MEMORANDUM OF THE NEW ZEALAND TRANSPORT AGENCY WAKA KOTAHI ON THE RCL HOMESTEAD BAY LIMITED DEVELOPMENT

22 October 2025

Figure 48: Engineering cross-section of diversion channel / bund along SH6 frontage

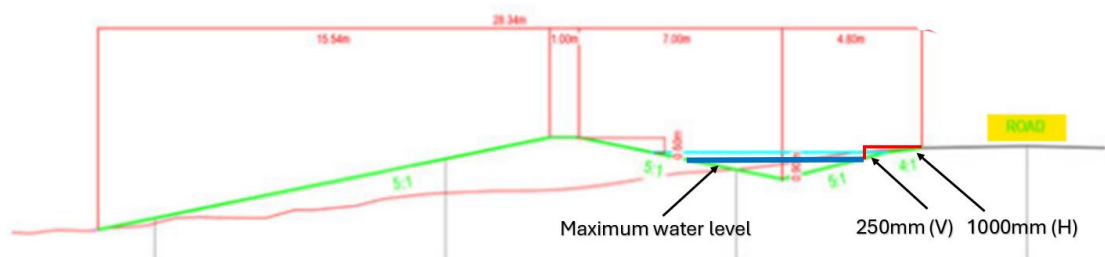
- 12.2 This diversion channel will be located adjacent to the carriageway of SH6, with a northern channel and southern channel commencing either side of the new roundabout access onto SH6. Upon review of the design of the diversion channel, NZTA requests an amendment to the cross-section of the diversion channel/bund along the SH6 frontage. Specifically, The height of the bund and rate of discharge through the diversion channel should be designed and constructed to ensure 250mm of freeboard is maintained at all times with the edge of the SH6 pavement formation and there is no standing water within a 1m horizontal offset (1000mm at a 4:1 slope) from the pavement to minimise the risk of pavement saturation. These measurements are illustrated (annotated) on the image (a reproduction of Figure 48 in the Application) below:
